## A D D E N D U M

Project: WCSC Milford Elementary

**Addendum No: 1**

ADDENDUM NO. 1, to Drawings and Specifications dated 02-14-2025, for the Renovation to Wawasee Middle School's Pool for the Wawasee Community School Corporation; as prepared by ELEVATUS Architecture, 111 E. Wayne Street, Suite 555, Fort Wayne, IN 46802

1 First Floor Architectural Plan  
1/8" = 1'-0"

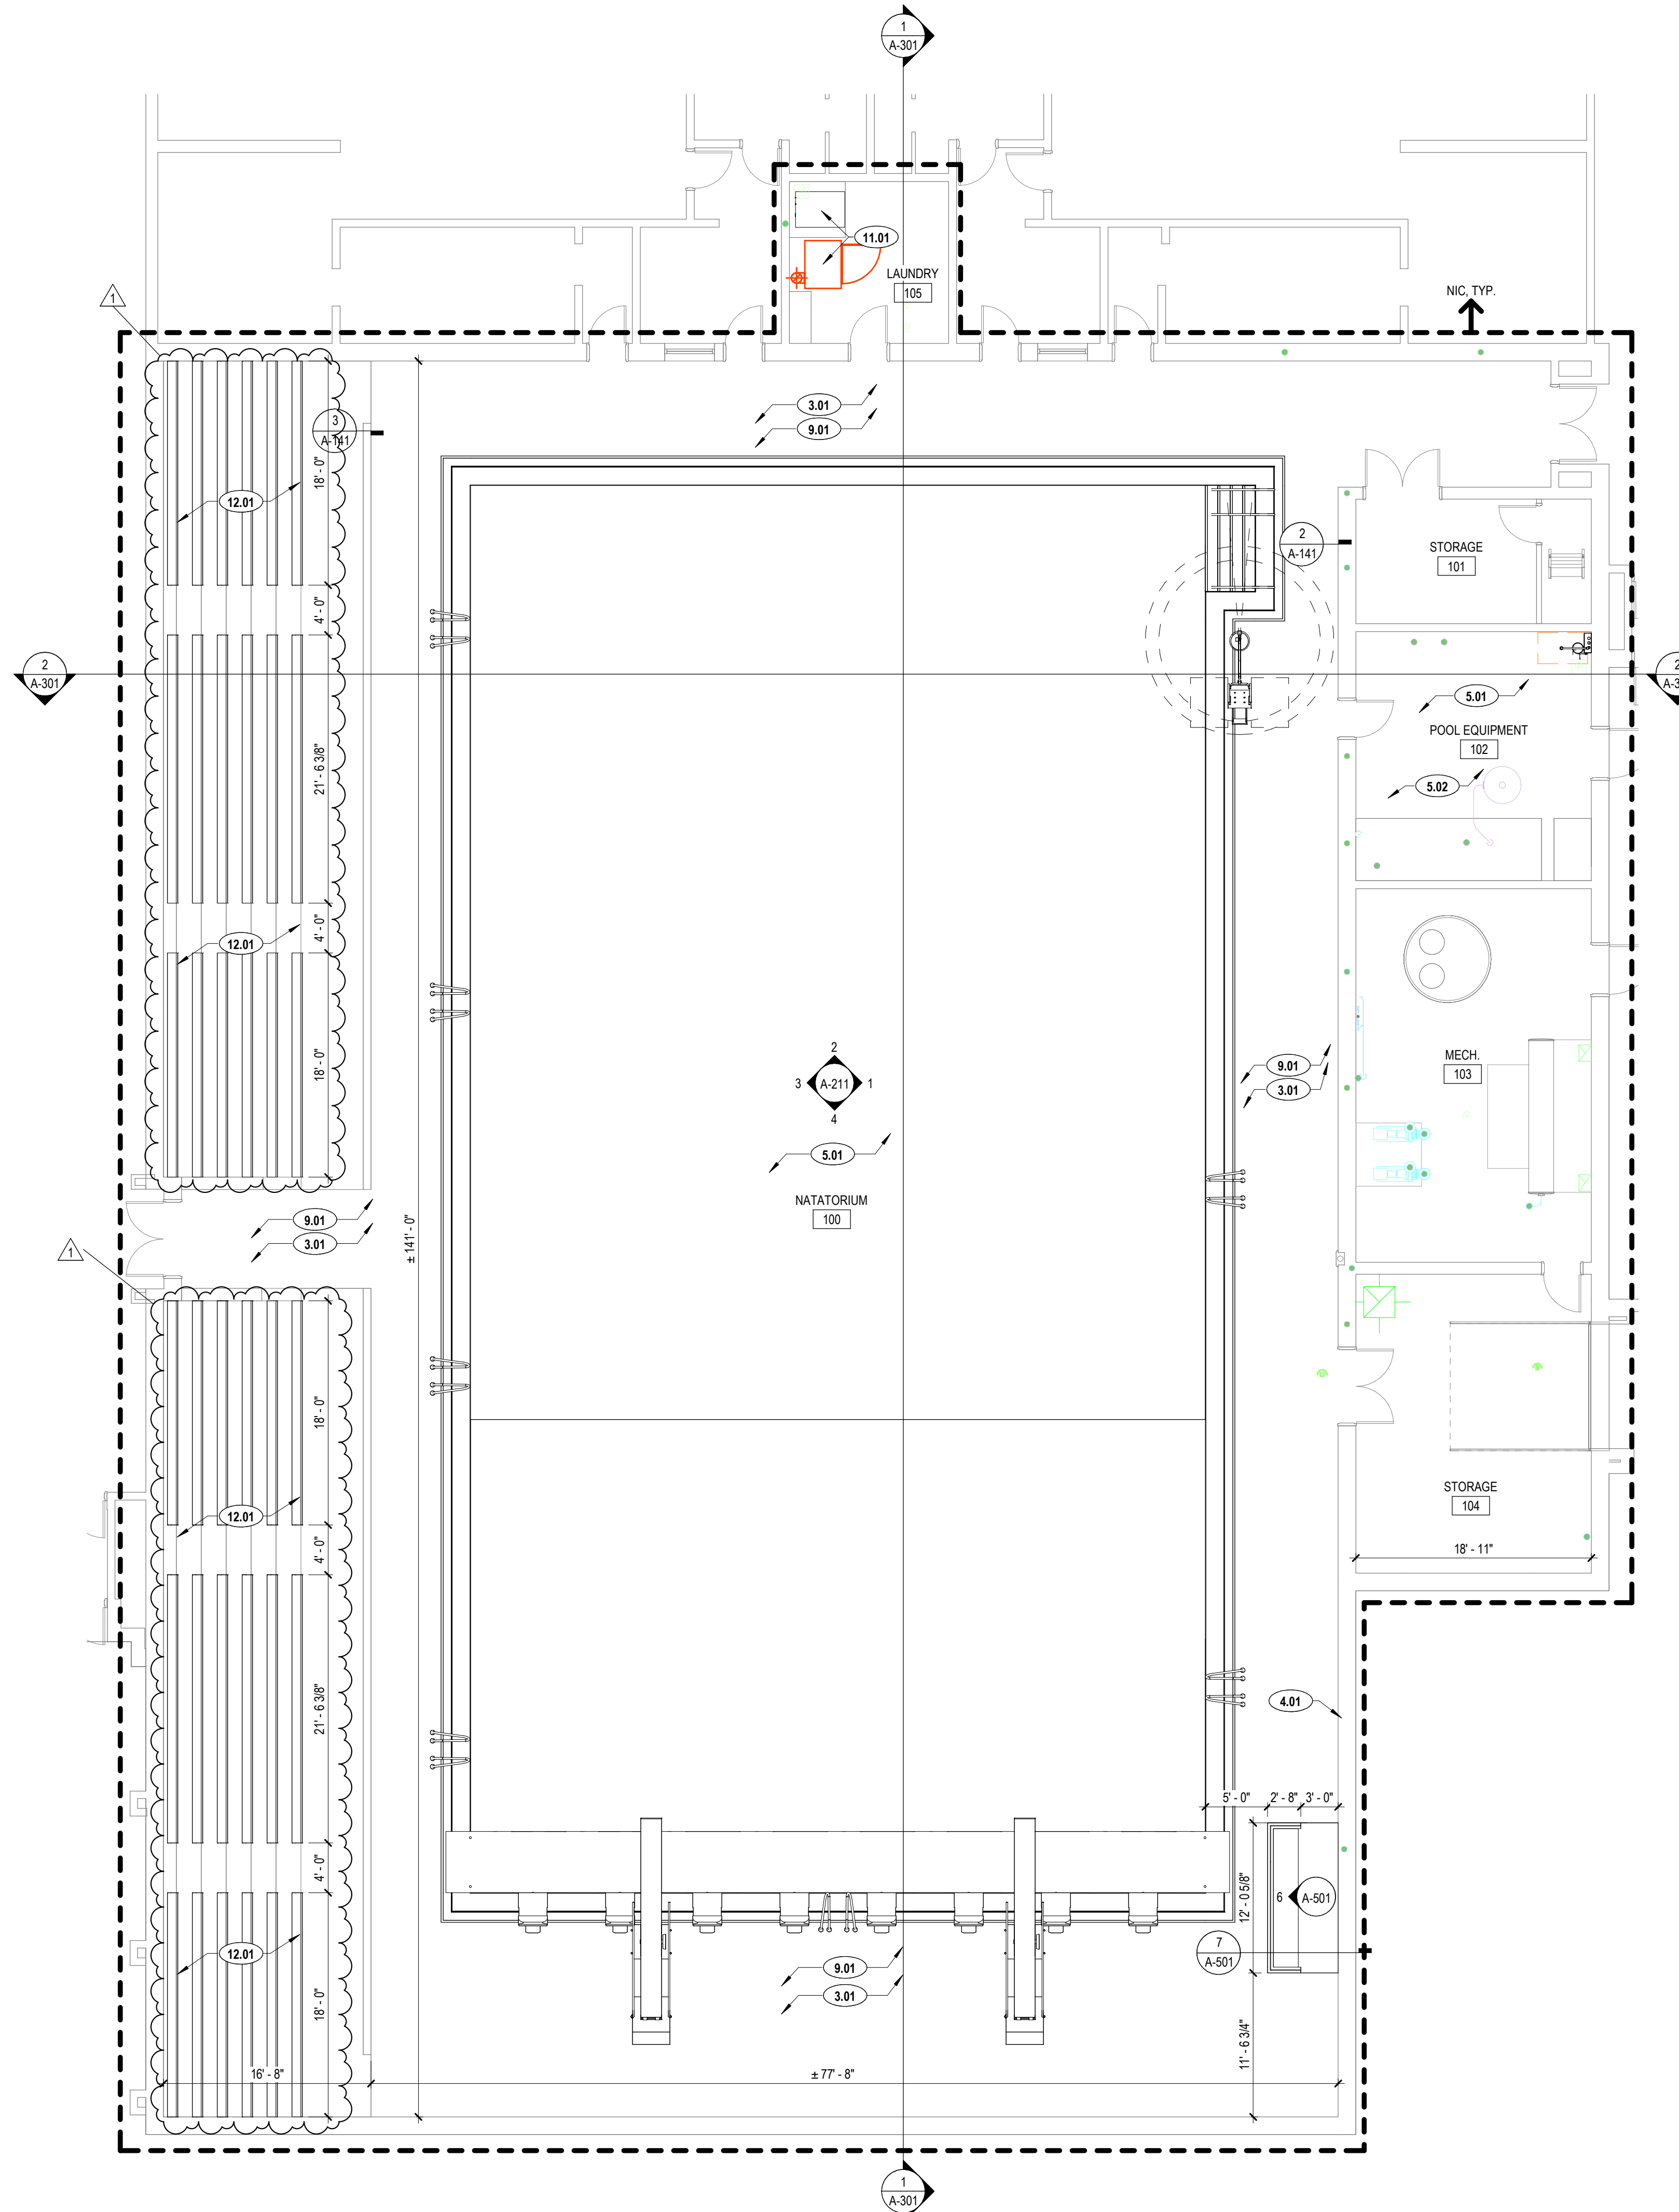
#### **ITEM NO. 2.01 - DRAWING NO. A-111 Architectural Floor Plans**

- A. Revision to proposed seating layout on 1/A-111
  - a. In Response to RFI BID-6**

**③ Elevation - Natorium West**  
1/4" = 1'-0"

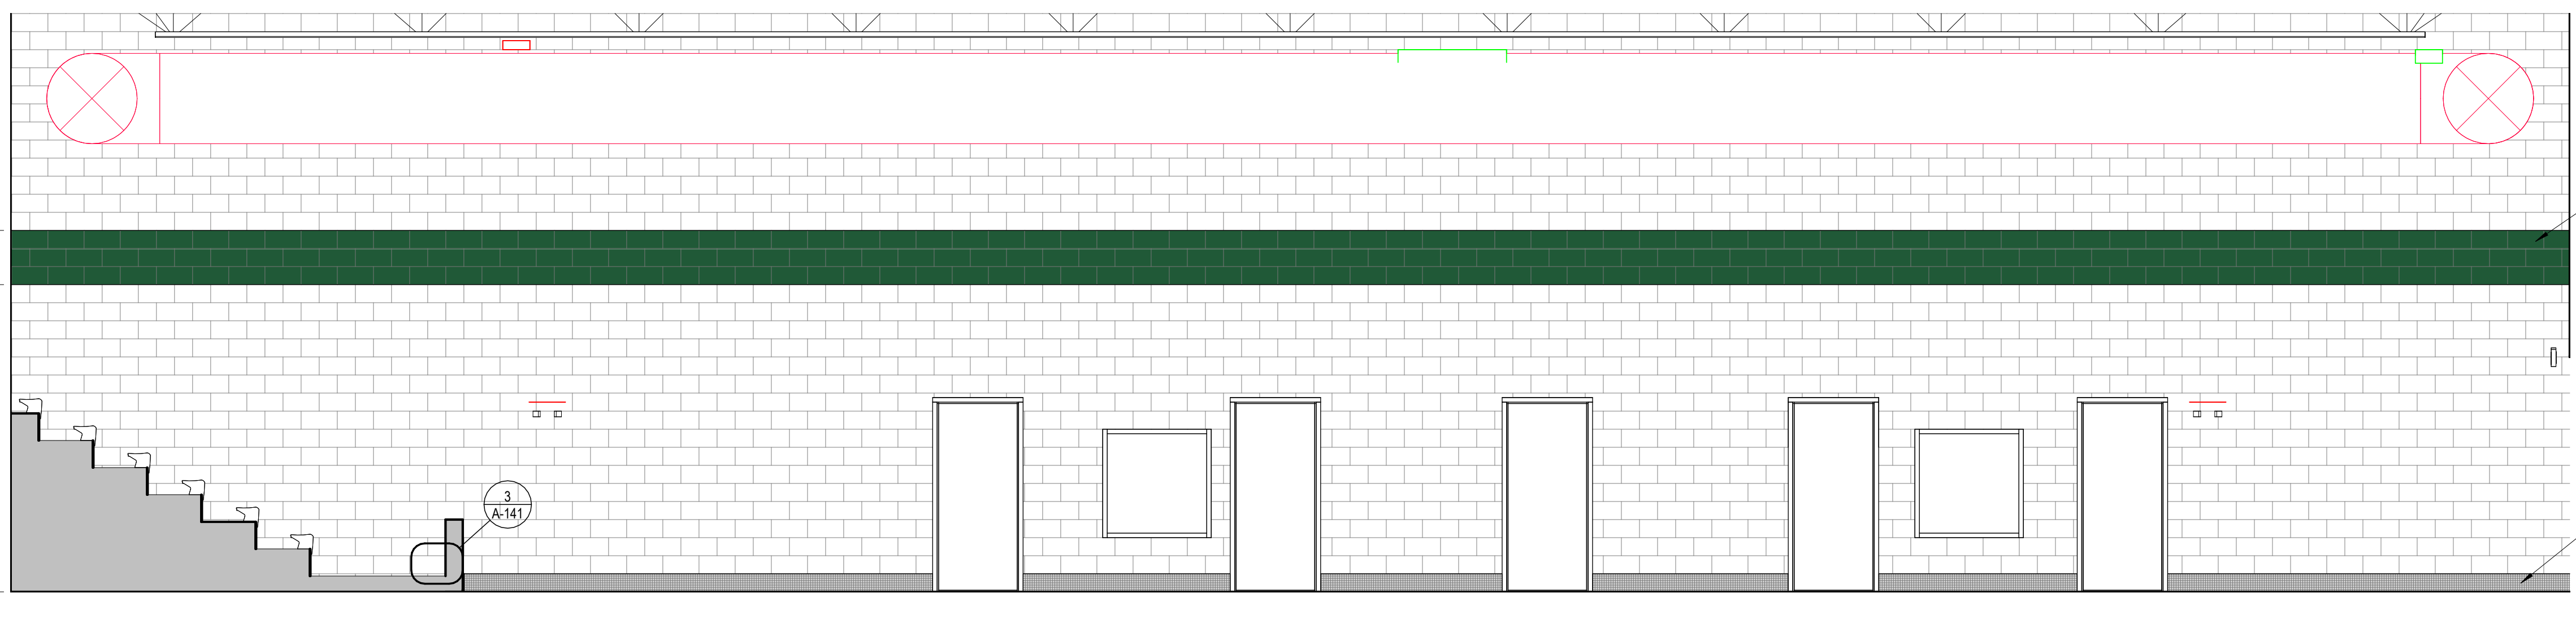
#### **ITEM NO. 2.02 - DRAWING NO. A-211 Interior Elevations**

- A. Revision to Notes on 3/A-211
  - a. In Response to RFI BID-1**
